Work Order ID 88284

Item ID: D3324-041

Item Name: Basket Base Assembly

DRAWING NO. D3324	TITLE BASKET BASE ASSEMBLY	REV. B	DART AEROSPACE LTD ENGINEERING ORDER		D.E.O. NO. D3324-B-1	SHEET NO. SHEET 1 OF 1	SCALE NTS
DRAWN AJS	CHECKED	MFG. APPR.	APPROVED	DE APPR.			
DATE 08.11.28	DATE 08.11.28	DATE 08/12/01	DATE 08/12/01	DATE 08.12.01

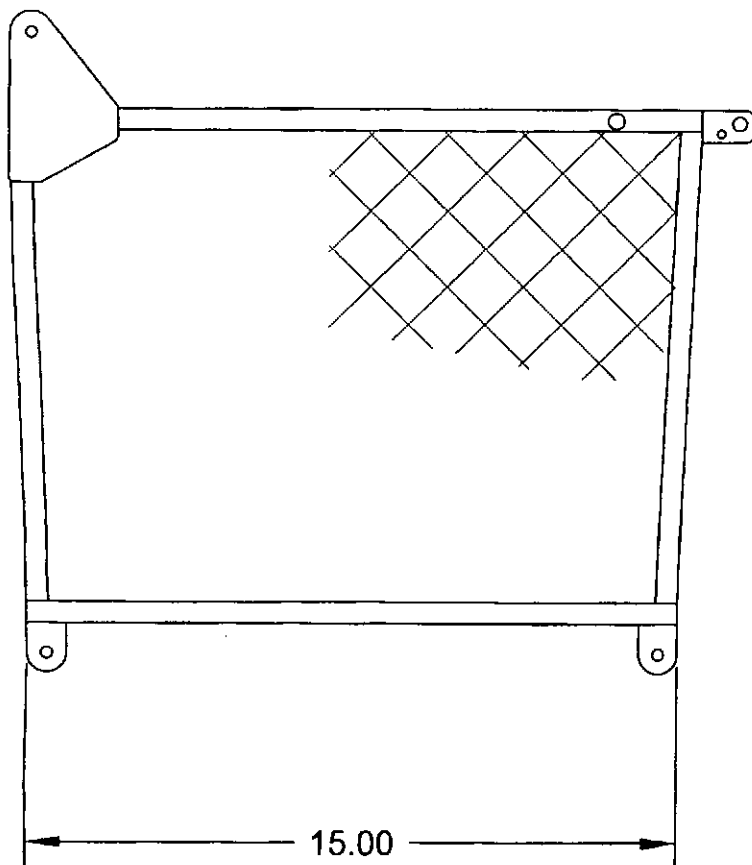
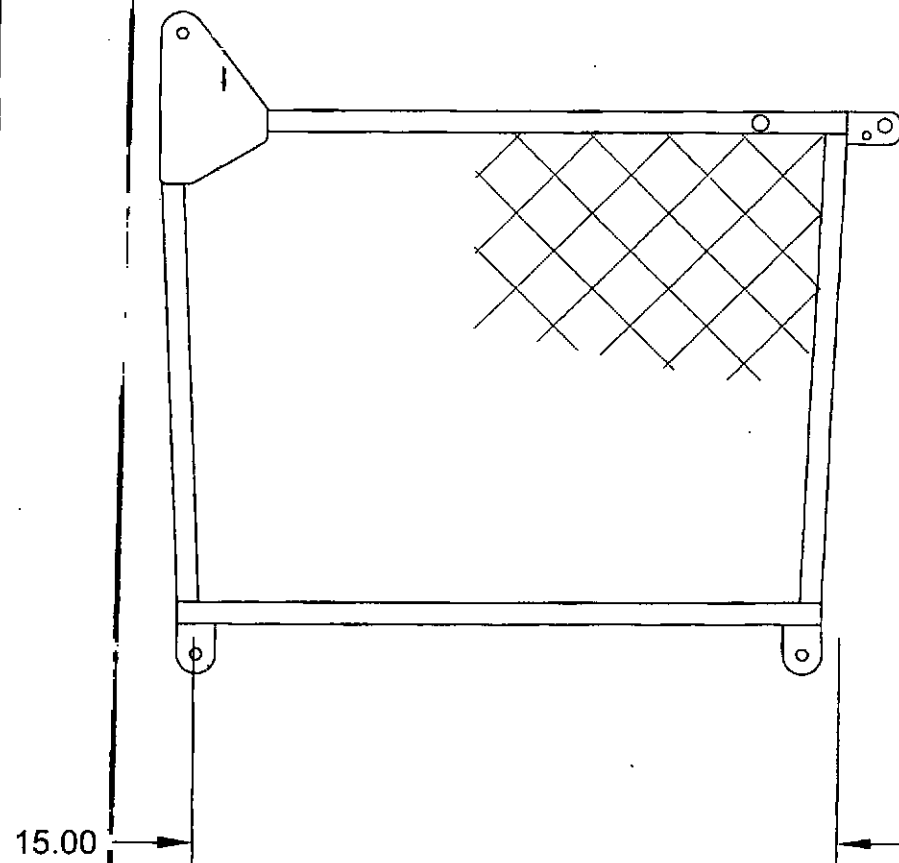
SHEET 2 MODIFY SIDE VIEW OF D3324-041 AS SHOWN:
